## RECALL NOTICE

RECALL CAMPAIGN No. 07V-282

# THOR CALIFORNIA RECALL SERVICE BULLETIN

**Ramp Door Secondary Latch Installation**

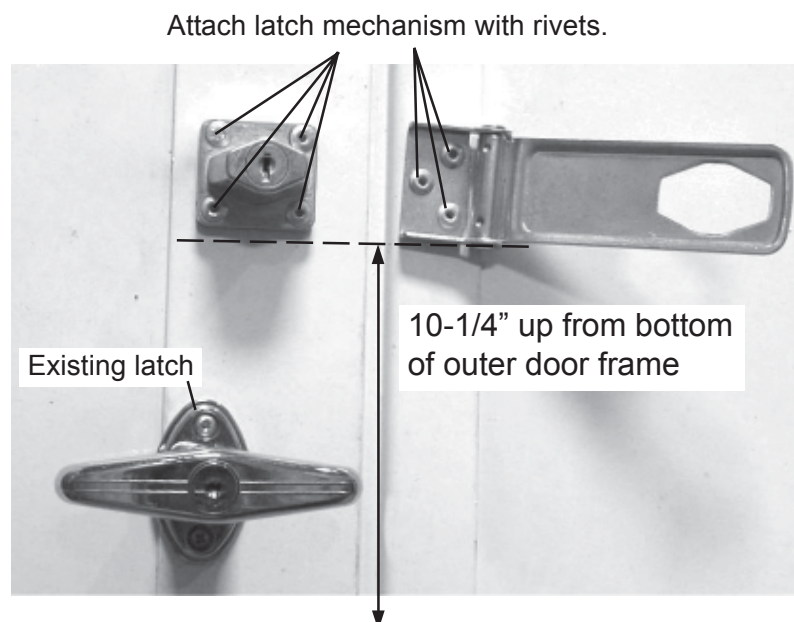
This bulletin describes the procedure to install a secondary latch mechanism and modify the original latch to prevent sudden opening of the ramp door if the primary latch fails or is not locked properly.

1. Measure up 10-1/4" from the bottom of the outer ramp door frame. Mark this position, and mark the attaching holes for latch hasp.
2. Drill holes through outer frame and into the sidewall deep enough to allow clearance for the rivets. Attach hasp with rivets. Do not use the screws included with the latch set.
3. Set the lock in position to align with the hasp. Mark and drill attaching holes.
4. Attach lock with rivets. Do not use the screws included with the latch set.
5. Test latch for proper operation. Give keys to customer.

6. On the inside of the door, mark the position of the original latch bar on the T-handle shaft.
7. While holding the latch bar in position, carefully remove the set screw and set it aside. With a sharp awl or pencil mark the set screw position through the set screw hole.
8. Pull the latch bar off the shaft.
9. With the tip of a 1/8" drill, carefully make a shallow dimple indent on the shaft at the set screw mark. **DO NOT DRILL THROUGH THE SHAFT.** Just make enough of an indent to allow the set screw to bite into the shaft.
10. Reinstall the latch bar to the original mark, and reinstall the set screw using Loctite thread lock on the threads. Tighten the set screw. Do not overtighten.
